From: [REDACTED]
To: [SizewellC](#)
Subject: Response to Issue Specific meeting ISH 11
Date: 14 September 2021 12:25:00
Attachments: [Responses to ExQ2 REP7-052 and REP7-059 Nick Scarr.pdf](#)

Responses to REP7-052 (EN010012-007054- Responses to ExQ2) and REP7-059 (Comments at Deadline 7 on Submissions from earlier deadlines and subsequent written submissions).

This paper is a response to the Applicant's replies to enquiries made by the Planning Inspectorate relating to my documents.

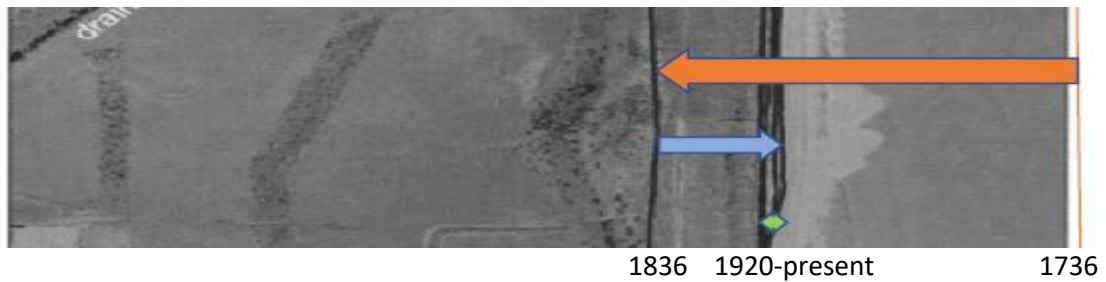
My response: The points stated above are in contradiction with those stated earlier—the Applicant states above in [REP7-052] (point 7 on page 4-5 above) the converse argument that, “... it became clear that the shoreline behaviour is incoherent and shows no clear linkage to the form of the bank.”?

It is also important to note that the Sizewell-Dunwich banks protect the inner and outer longshore bars which do have a marked effect on moderate and low-level storms and hence shoreline erosion.
